GROVE CITY, OHIO - CITY COUNCIL Agenda

July 21, 2025

| <u>Ordinance C-30-25</u> | Approve a Special Use Permit for an Antenna Tower for Parkway Centre Arcadia Tower located at 1620 Buckeye Place. First reading. |
| <u>Resolution CR-27-25</u> | Approve a Development Plan for Ginn Drive Bungalows located at the northeast corner of Park Street and Ginn Drive within the Beulah Park Living Community. |

C-3.1

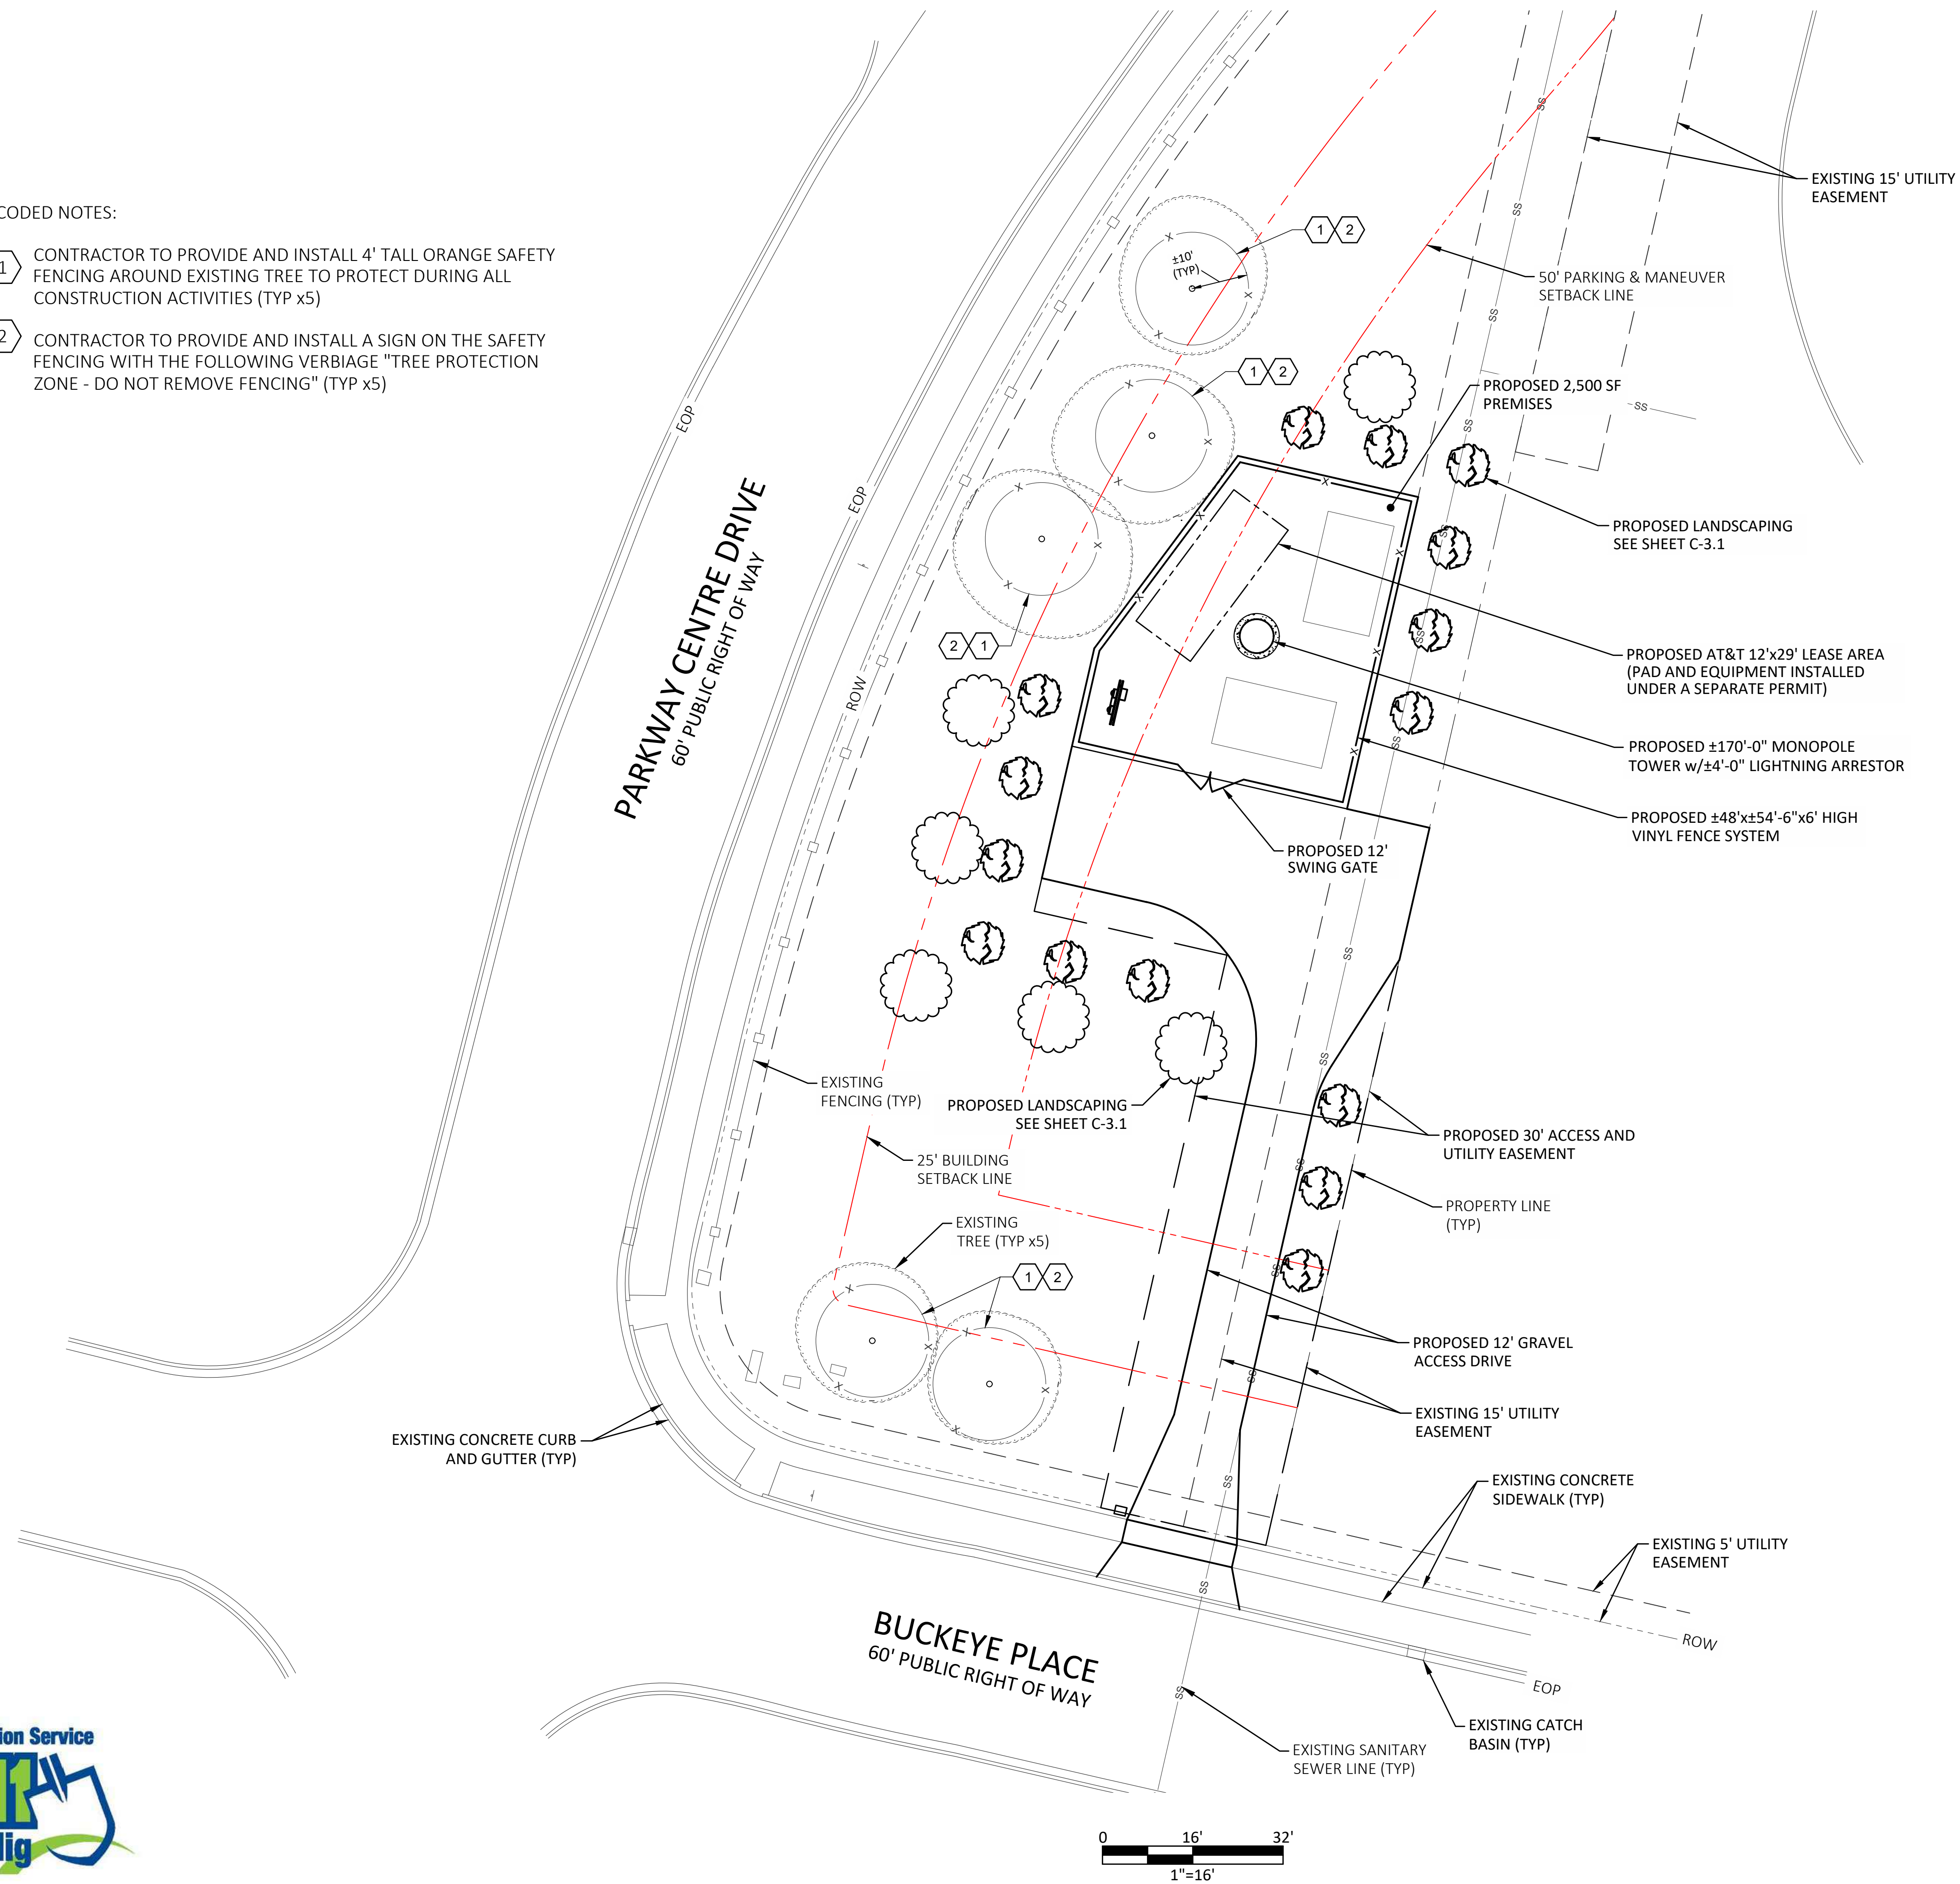
1. Please add an additional Blue Spruce along the east side of the gravel drive south of the fenced area. ***The additional Blue Spruce has been added to the plans see attached C-3.1 in the construction plans showing the additional Blue Spruce.***

3. The landscape plan should be amended to note that 50% of the burlap and wire cage are to be removed from the root ball of all trees. ***I have attached a revised page of the plans under tree planting detail where this provision is listed in the construction drawings on page C-3.1.***

4. The City's Urban Forester recommends replacing the proposed Redbuds with a different species, as Redbuds do not do well with full sun exposure. ***On page C-3.1 we have revised the species from Redbud to a Flowering Dogwood.***

DATE: MAY 27, 2025
SET: DEVELOPMENT PLAN
PAGE: A2.0

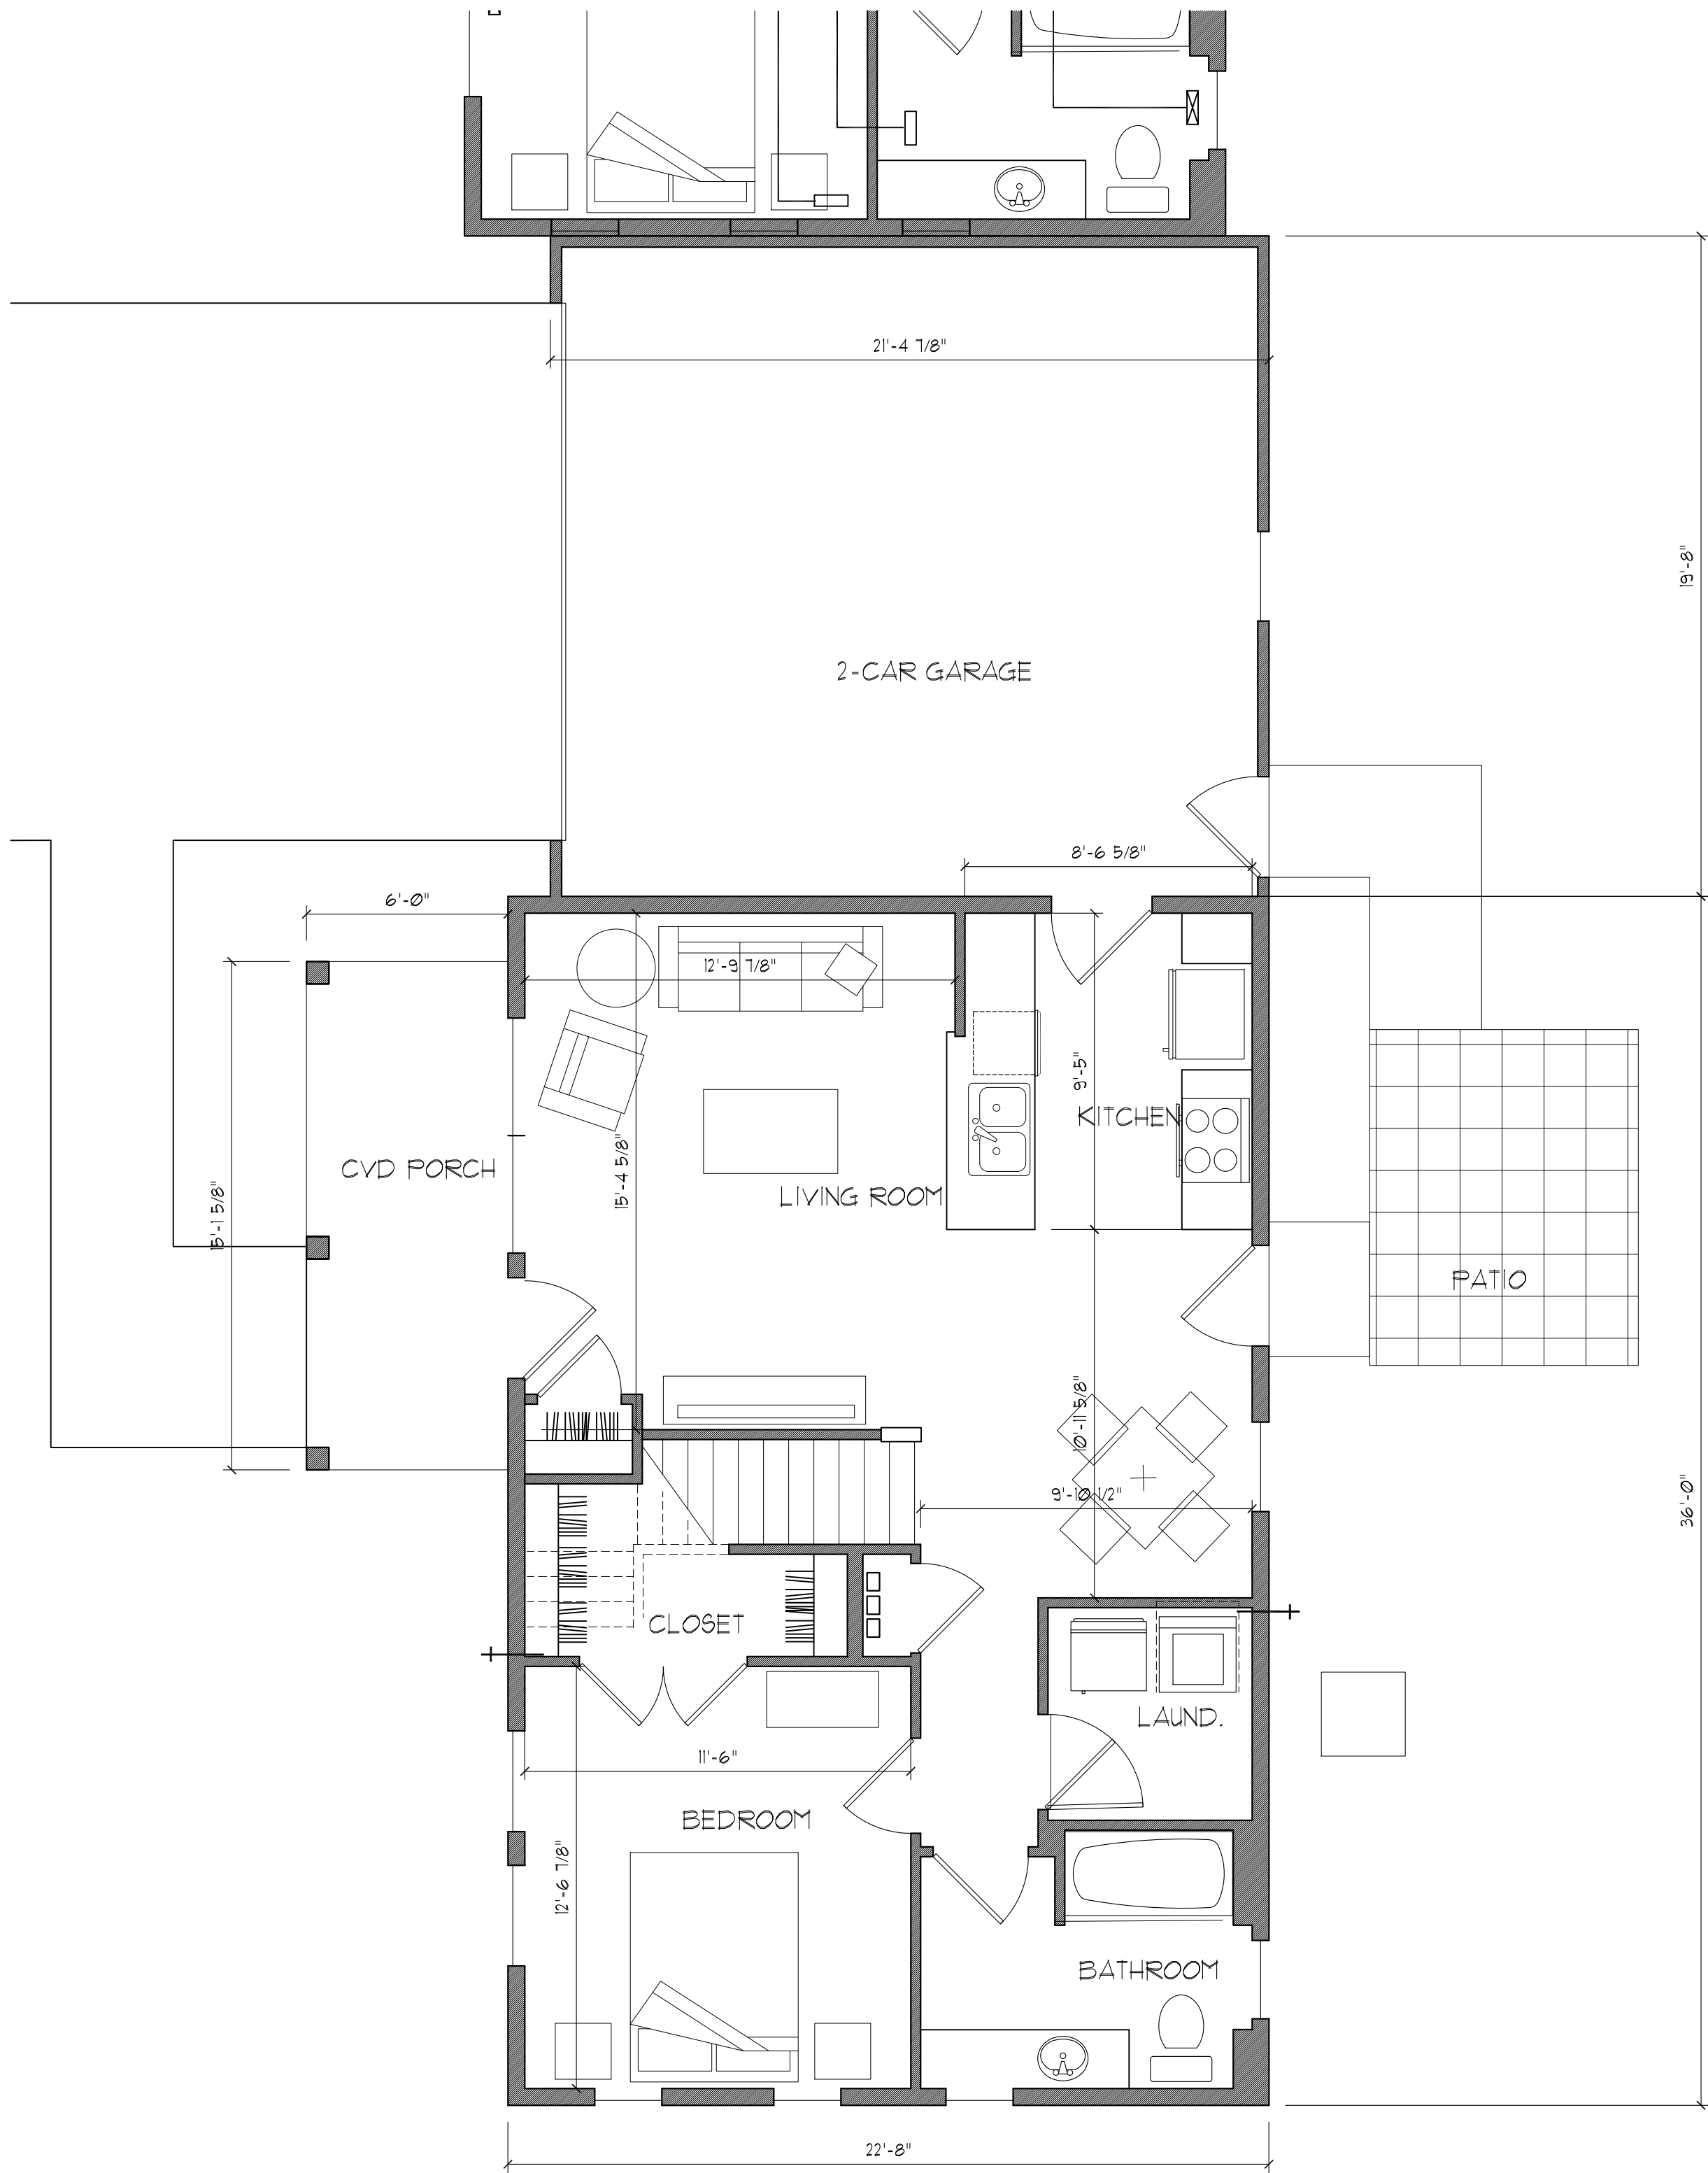
8. **Comment:** General Comments. The labels on sheet A2.0 appear to have been misprinted and are difficult to decipher.
